**CLEARINGHOUSE RULE 99-122**

AN ORDER to renumber Comm 90.19 (8) (c) 3. and 90.19 (8) (c) 4. a.; to renumber and amend Comm 90.06 (2); to amend Comm 90.01, 90.03 (19) Note, 90.08 (8) (a) and (14), 90.09 (1) (a), 90.10 (1), 90.12 (1) Note and 90.19 (2); to repeal and recreate Comm 2.68, 90.02 (2), 90.04 (1) to (4), 90.08 (10) (d) and 90.19 (6) (a); and to create Comm 2.02 (4) (d), 2.68 Table 2.68-1, 90.03 (15) Note, 90.08 (12) Note, 90.19 (6) (d) Note, Appendix A-90.03 (15) and Appendix A-90.19 (6),, relating to the design and construction of public swimming pools.

Submitted by **DEPARTMENT OF COMMERCE**

**LEGISLATIVE COUNCIL RULES CLEARINGHOUSE REPORT**

A-90.19 (6) Sample sketch depicting whirlpool location and measurements for access, as specified in s. Comm 90.19 (6) (a) 2.

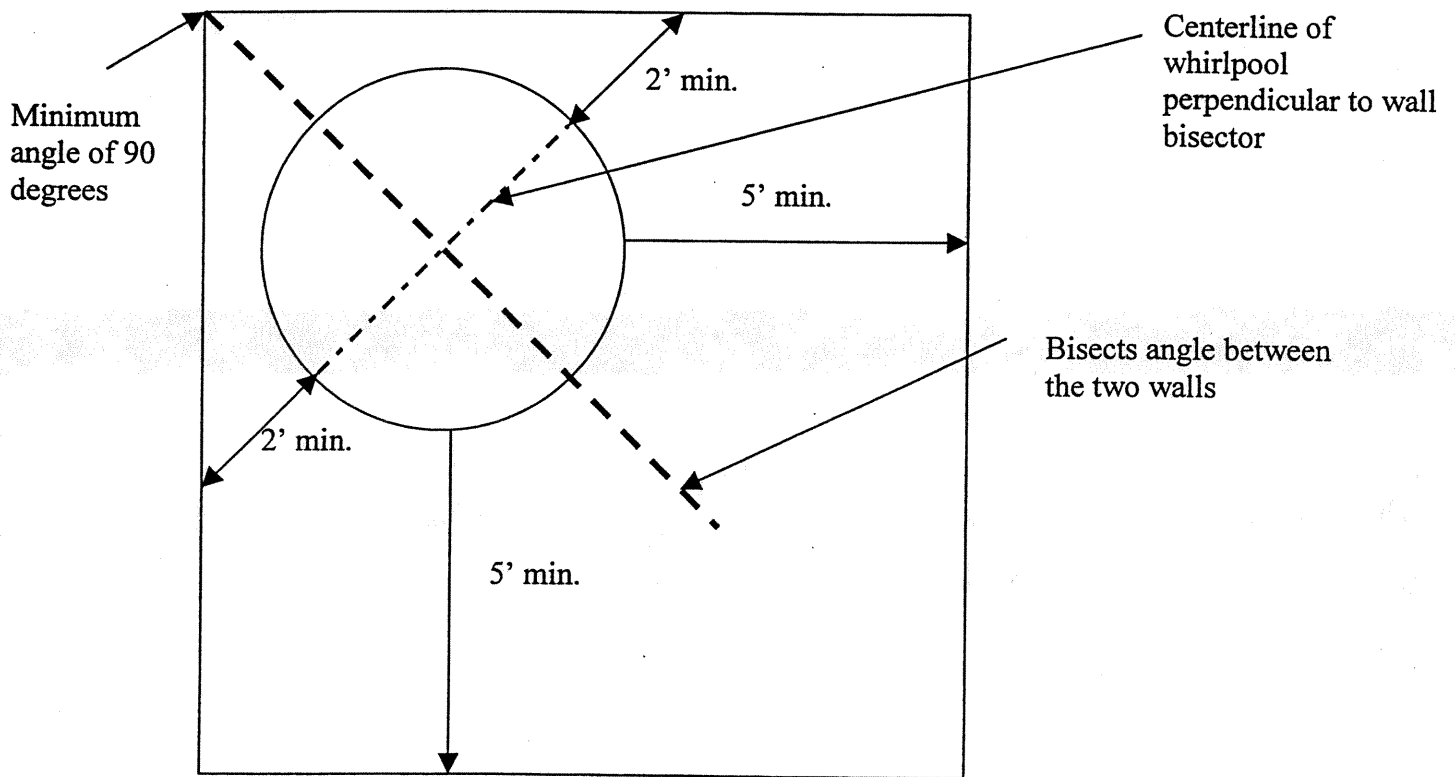
k. SECTIONS 22 and 23 purport to create portions of an appendix in ch. Comm 90. However, it appears that ch. Comm 90 does not currently have an appendix. If a different proposed rule is creating an appendix, it should be cited.
